Project Name: GOLDSTEIN RESIDENCE

Project Description: (If additional space required, please attach a narrative summary.)
REMOVE EXISTING GARAGE ROOF & BUILD NEW SECOND FLOOR BEDROOM ABOVE THE EXISTING GARAGE. BUILD NEW PORTICO ON THE FRONT FACADE.

REFERRAL TO THE ZONING BOARD OF APPEALS

PLOT PLAN

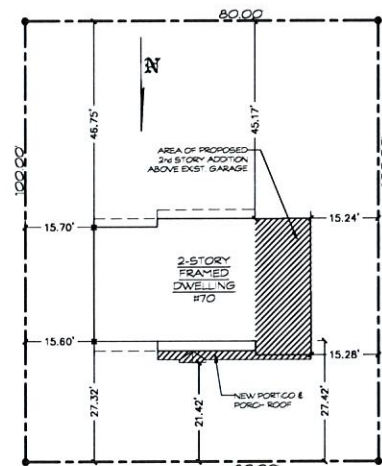
Chapter 43, Table 3.12, RG District
Column 4 Max FAR 30% w/ 34% propsoed
Column 8, Required Front Yard 25' w/ 21.42' proposed

Two Variances required

Front portico, garage 2nd story addition
